Clark & Enersen Project No.: 097-045-19
LPS Bid #: 11090

ADDENDUM NO. 2

Project:	LPS - New NW & SE Activities Complexes
Project No.:	097-045-19
Meeting Date:	10/17/2024
Meeting Time:	2PM
Location:	LPS Operations

Proposed Substitution: InLine Backstop Netting System

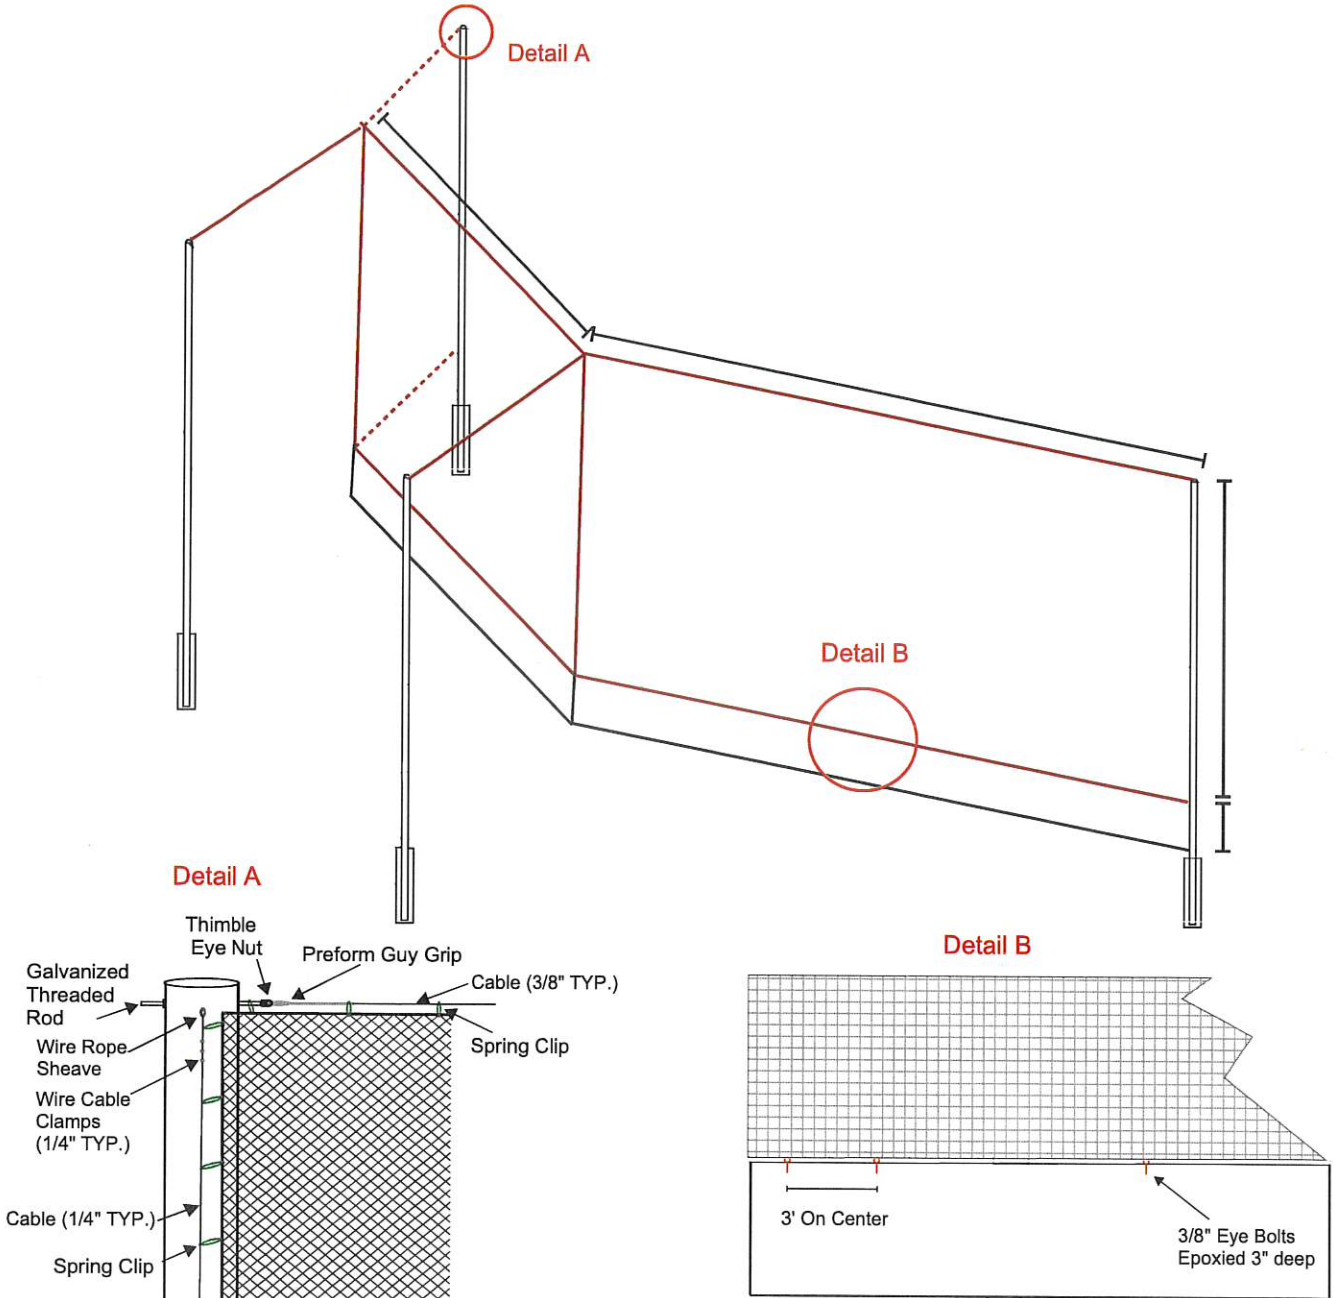
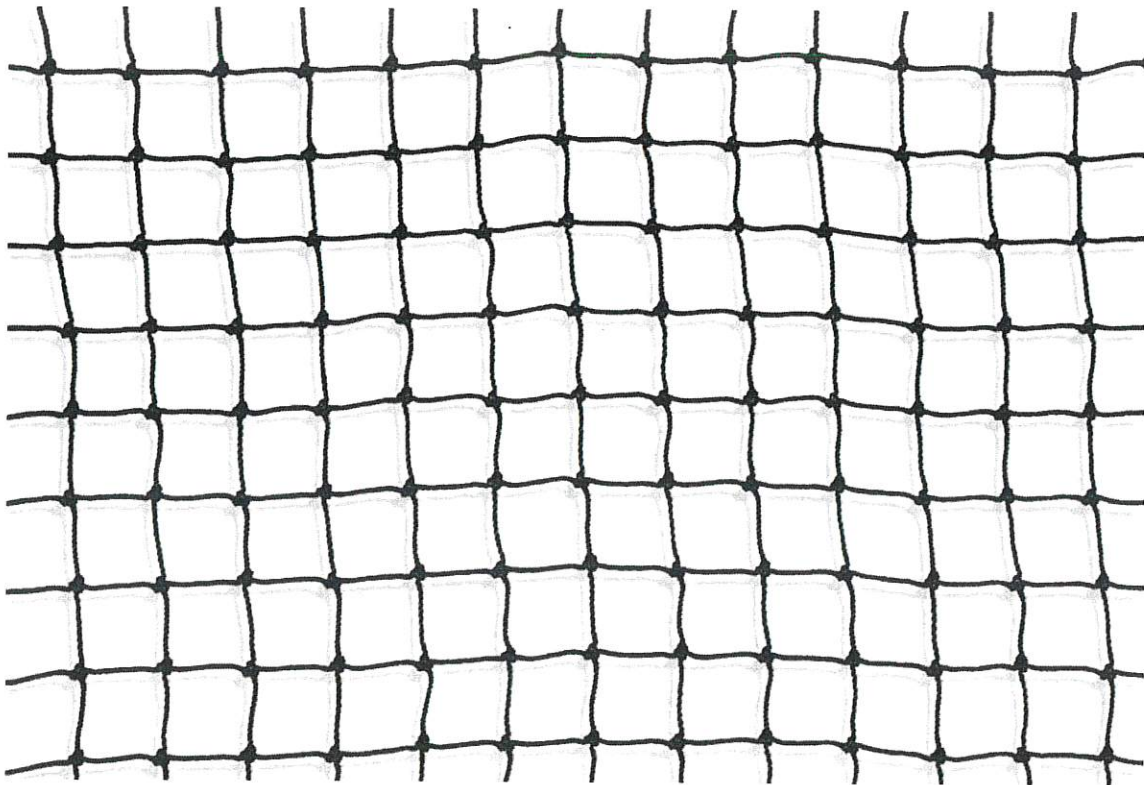
- Item 2-9:** **Question:**
Please see the attached Sports Field Equipment substitution Request.
Response:
The substitution request is not accepted. There will be no tie-back backstop netting systems allowed on this project.

Description: Pole to Pole Tension Net System
